Re: Planning Scheme Amendment C107 – Bannockburn South East Precinct Structure Plan

I write in response to your referral of the above-mentioned Amendment which seeks to implement the Bannockburn South East Precinct Structure Plan (PSP) and Development Contributions Plan (DCP).

Barwon Water has reviewed the relevant draft PSP documents, and make the following submission to the PSP document (March 2024) which should be incorporated in the final version.

Figure-1 – Preferred Pump Station Location

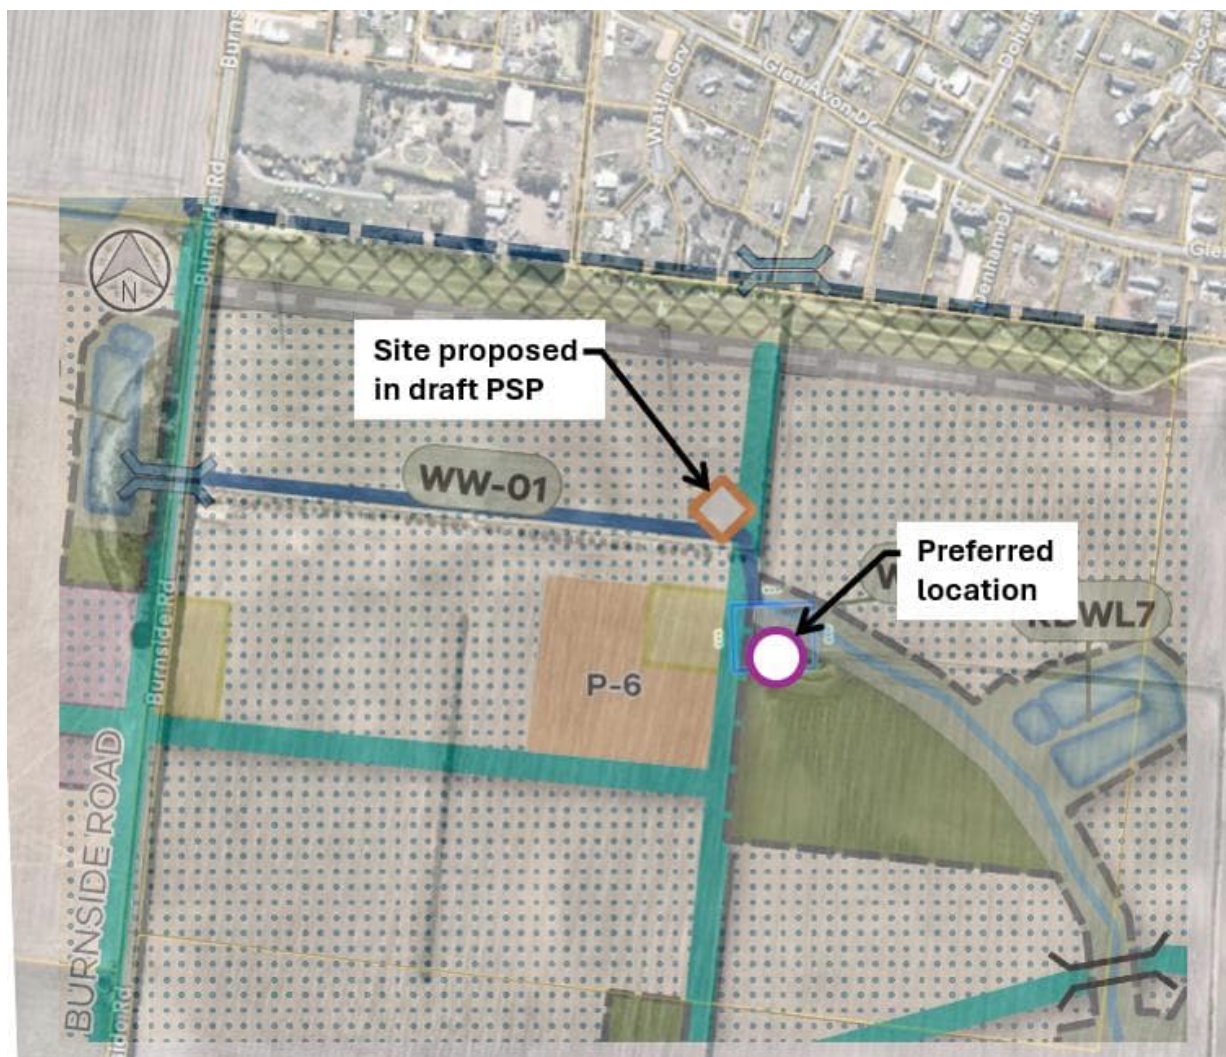
Barwon Water request that the location of the pump station is amended on the Place Based Plan as the site nominated by VPA in the draft PSP is not suitable due to its higher elevation. We are currently liaising with Ramsey Property Group to position this asset within 279 Burnside Road Bannockburn near the existing dam, which is the lowest point. This correlates to an area currently listed as credited open space, SR-02, in the Place Based Plan.

Barwon Water request that the future sewer pump station is co-located within credited open space SR-02, on the south side of the drainage line.

This could result in the potential reduction of open space, and or adjustment to ensure the area remains 6Ha. Barwon Water is happy to work with the VPA, Golden Plains Shire and the landowner to secure this location within the final PSP documentation.

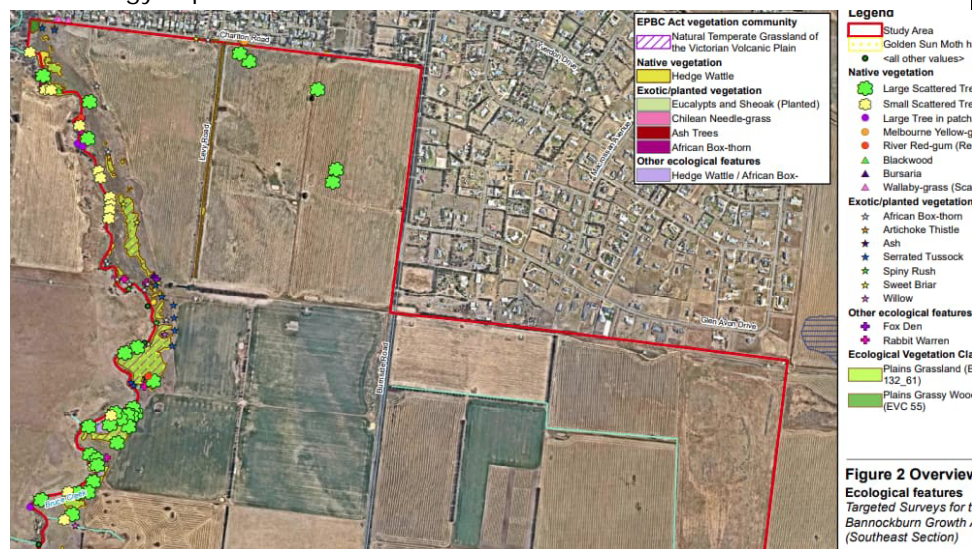
33	G35	<p>Please remove reference to She Oaks. While it is referenced in earlier work, it is now not supported as it is not likely to ever occur and does not have the support of Wadawurrung Traditional Owners Aboriginal Corporation.</p>
37	Plan 7	<p>Barwon Water notes Plan 7 and makes the following request</p> <ul style="list-style-type: none"> There may be issues locating the proposed second Barwon Water funded pump station in the water ways and drainage reserve such that it be shifted and located as shown below. This can be determined at a later date.

<ul style="list-style-type: none"> • • WW-01 appears to be quite a large drainage asset conveying flows underground from RBWL6 to RBWL7. This location was previously shown as part of the drainage network, presumably with some overland flow. This would be favoured from an IWM perspective to retain more water in the landscape. In addition, a larger DN375 BW sewer is likely along this alignment. Given these two large assets, some space may need to be allocated and shown in the PSP, see below
--	--	---
